To: Departments Concerned
From: Alan Stephenson
Planning & Development Department Director
Date: December 20, 2021
Subject: **P.H.O. APPLICATION NO. PHO-4-21--Z-47-19-7** – Notice of Pending Actions
by the **Planning Hearing Officer**

APPLICATION NO: PHO-4-21--Z-47-19

Request For: Stipulation Modification

Reason for Request: Review of site plan, landscape plan, and elevations per Stipulation 24.

Proposed Site Plan

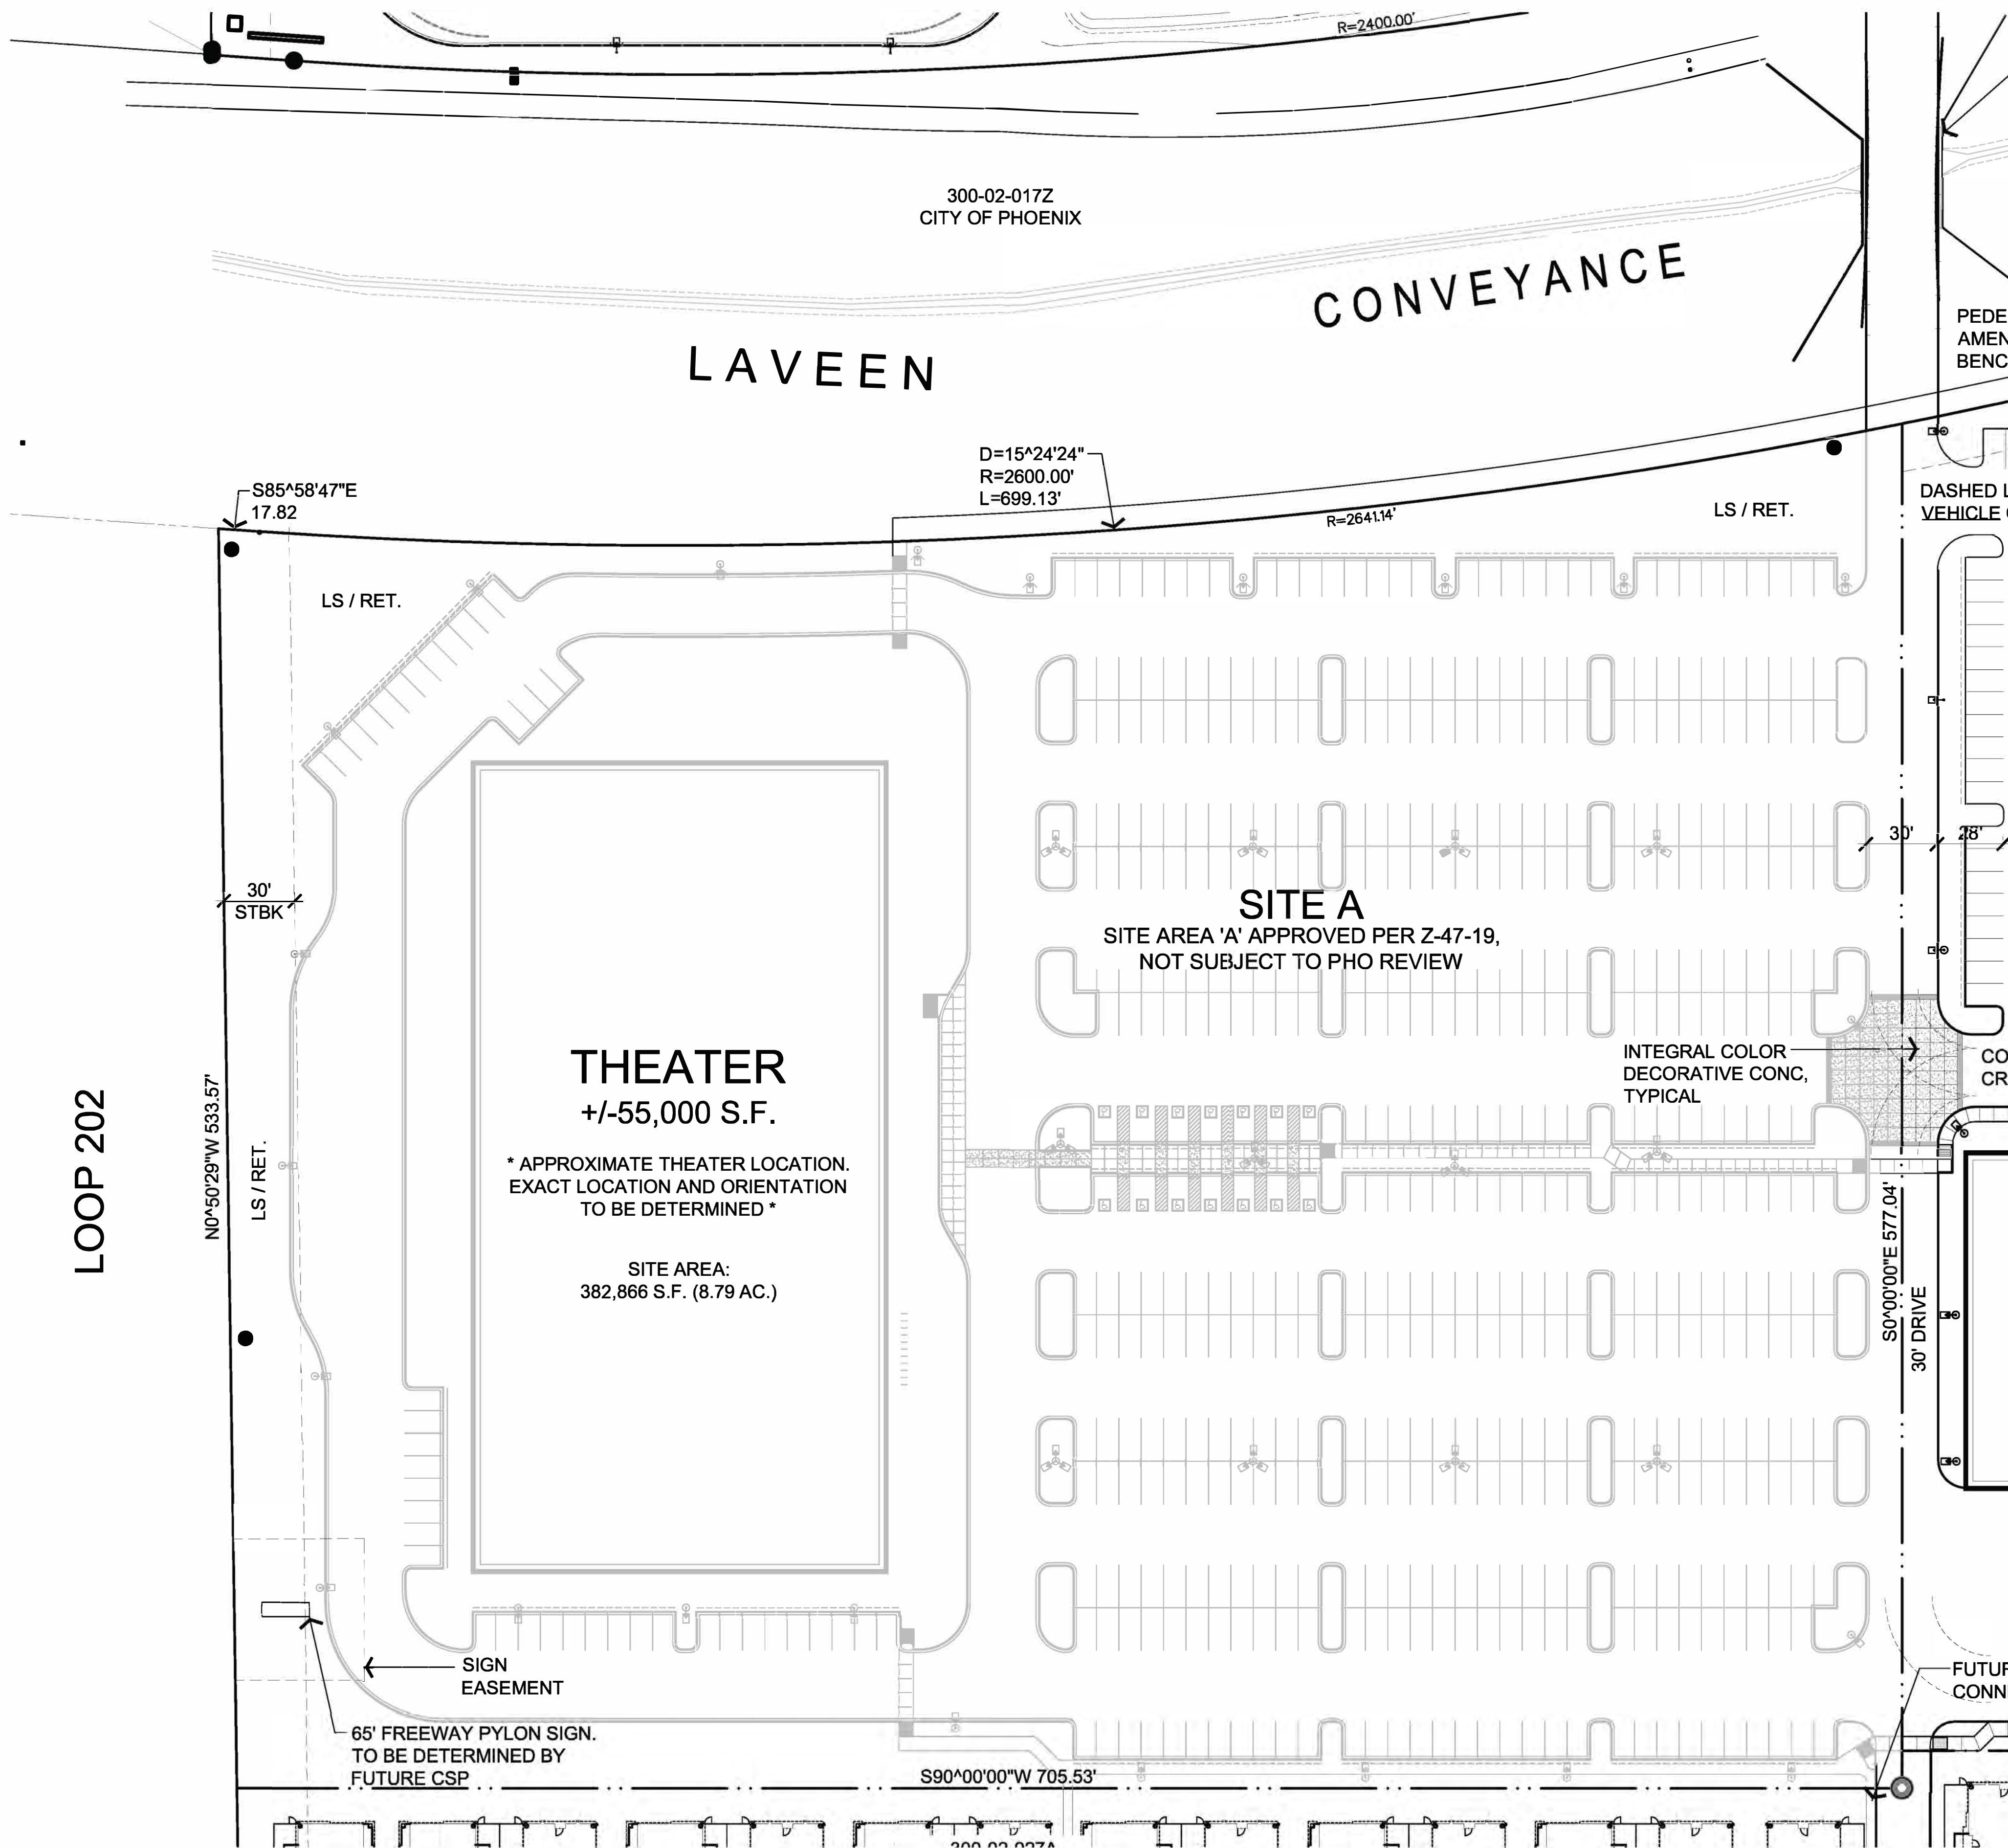
- C. STIP 8 ALL TRAILS WILL HAVE 50% SHADING.
- SITE B (RETAIL):
- J. STIP 24 SITE PLAN REVIEW THROUGH PUBLIC HEARING REQUIRED. APPY THROUGH PHO. I WOULD RECOMMEND SENDING ME AN EMAIL WITH THE PLAN AND ELEVATIONS AHEAD OF TIME TO CHECK STIPULATION COMPLIANCE TO AVOID DELAYS THROUGH THE PHO. THE PROPOSED PLAN IS FOR CONNECTIONS ONLY AND DOES NOT CREATE A SITE PLAN FOR SITE B. NO PUBLIC PLAN REQUIRED UNTIL SITE B SITE PLAN IS DEVELOPED.

- K. STIP 24 A) CREATE A SECOND 6' SIDEWALK CONNECTION 59TH AVE TO BUILDINGS. ONE IS SHOWN.
 - L. STIP 24 A) SHOW TRAIL LOCATION WITH 2 PEDESTRIAN CONNECTIONS AND AMENITIES.

- R. STIP 27 SHOW CALCULATIONS FOR 20% OF SURFACE PARKING TO BE SHADED.
 - S. STIP 28 NOTE 4 BIKE PARKING SPACES (2 U RACKS) AT EACH BUILDING.
 - T. STIP 29 ALL BUILDINGS THAT FRONT PARKING AREAS WILL HAVE 30% OF FRONTAGE WITH PLANTING AREAS.

- U. STIP 31 SHOW 10' SHARED USE PATH ON 59TH AVE
